GULMOHAR RESIDENCY

Details of Additions & Alterations

Description	Direction	Owners & Developers :	Date :	Prepared By :	Approved By :	Scale :	Promoted by
WORKING PLAN-1360 Sft -A1 TYPE	N	Modi Reality Mallapur LLP Project Name & Phase : Gulmohar Residency	25.09.2020	Jayapradha Soham Modi	N.T.S	N.T.S	Modi Properties Pvt Ltd Phone: +91-40-66335551

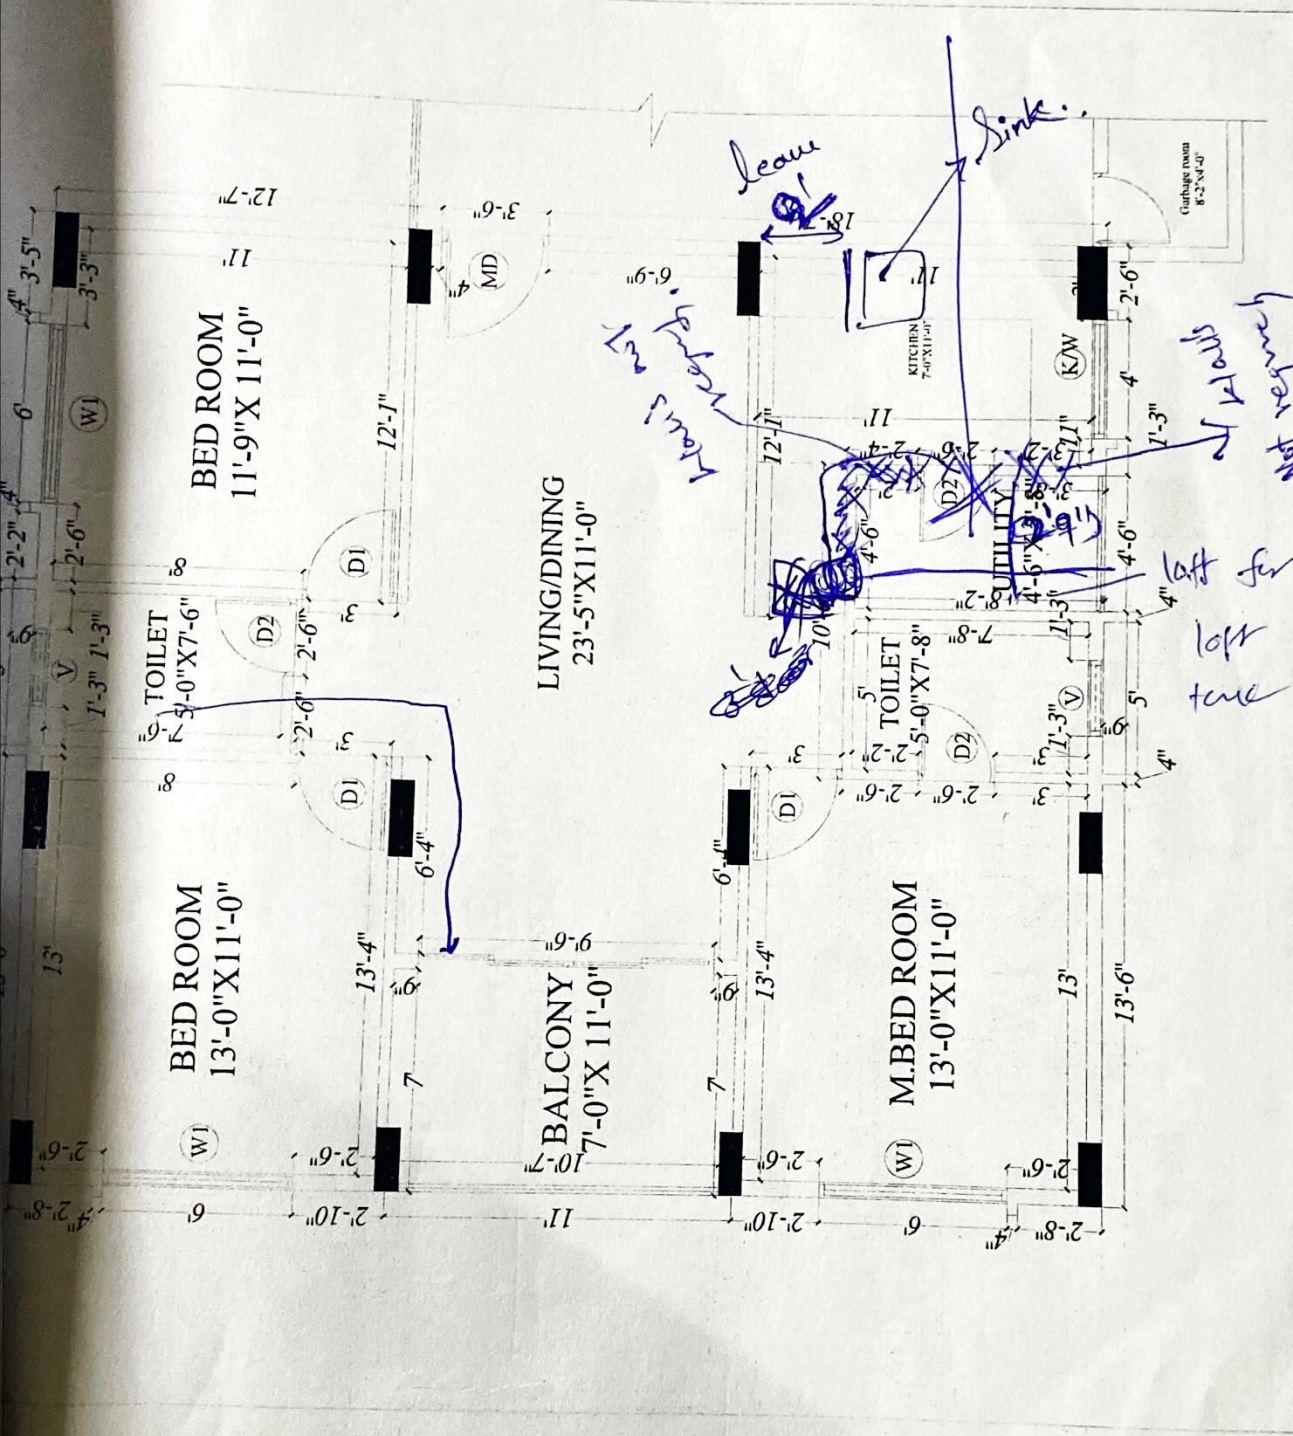
② 1 Wall light Point in all Bedroom.

- ① false only same as A-207
- ② Plumbing lines to be on above with
in utility.

Door Cancelled
utility size
4' x 2'9"
